Subarunet Announcement

UPDATE Safety Recall/STOP SALE: WRP-23 Driveshaft Failure

Service, Parts, and Claim Instructions

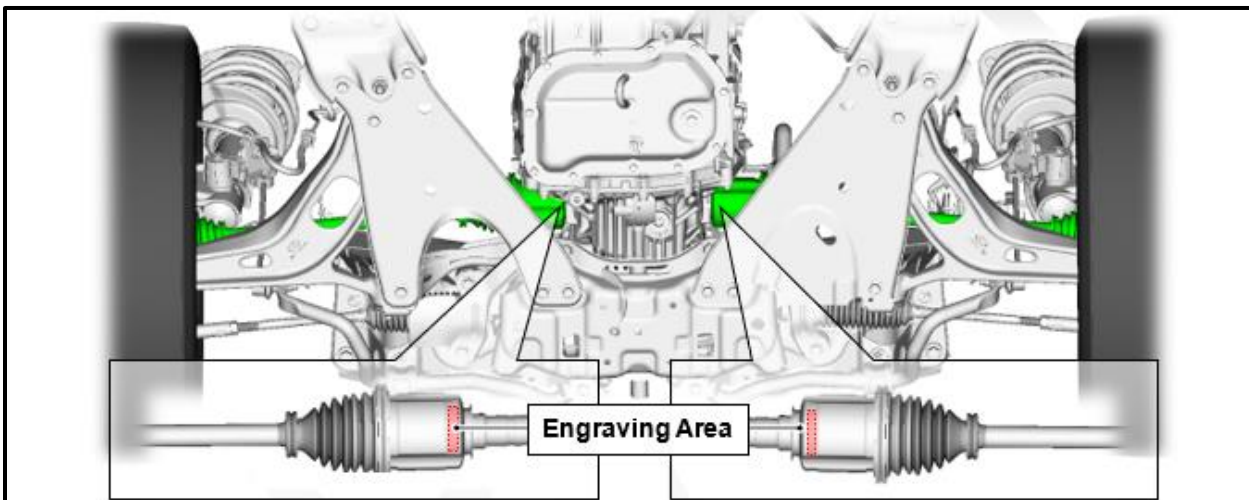
STEP 2: Rotate the left/right front wheel to find the 2-Line engraving located on both the left and right outer race portions of the inner drive shaft joints.

- There are three engravings on the drive shaft outer race. One is the lot number, and the others are NOT lot numbers. The lot number engraving is shown in the images below.
- SLOWLY rotate the wheel to find the lot number. Remove dust and/or dirt using a clean cloth to make the numbers more visible. A flashlight will also aid in the reading.

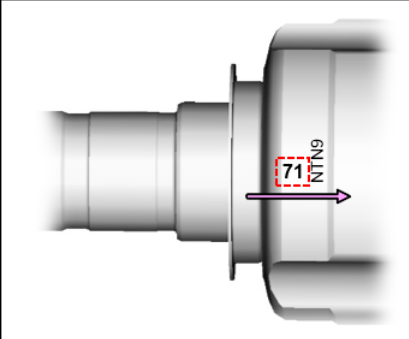
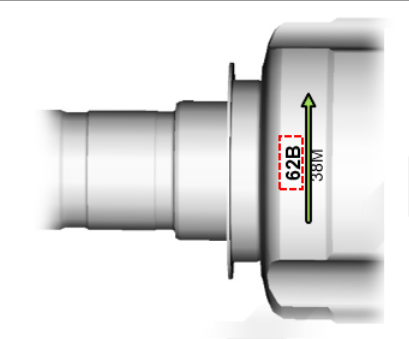
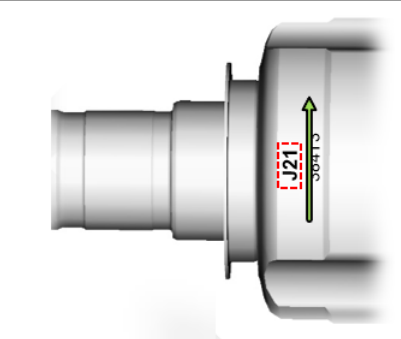
There is one engraving of either of the following types on the outer race. The 2-digit number (followed by a letter) in the red frame below is a lot number.

There are two engravings of the following style on the outer race. However, this 1-line engraving is NOT a lot number.

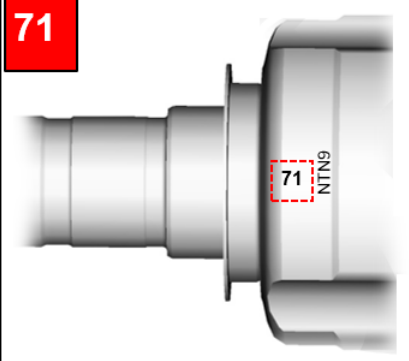
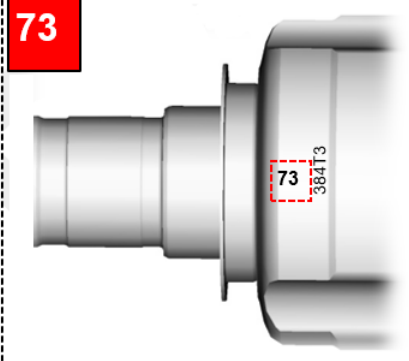
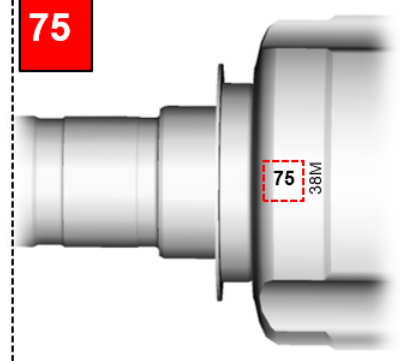
STEP 3: Confirm the lot number engraving type and read the lot number. See the tables below for further detail.

Engraving Type 1	Engraving Type 2	Engraving Type 3
2-digit number is engraved in the axis direction.	3 digit-character starting with a number is engraved in the circumferential direction.	3 digit-character starting with a number is engraved in the circumferential direction.

Results		
Engraving style 1	Refer to the table below for further details.	
Engraving style 2 or 3	The drive shaft is a good part. Record and attach the lot number to the repair order.

71		73		75	
Results					
71, 73 or 75		The drive shaft is a defective part. The vehicle is to be placed on HOLD under Stop Sale until further notice.			
Other 2-digit numbers		The drive shaft is a good part. Record and attach the lot number to the repair order.
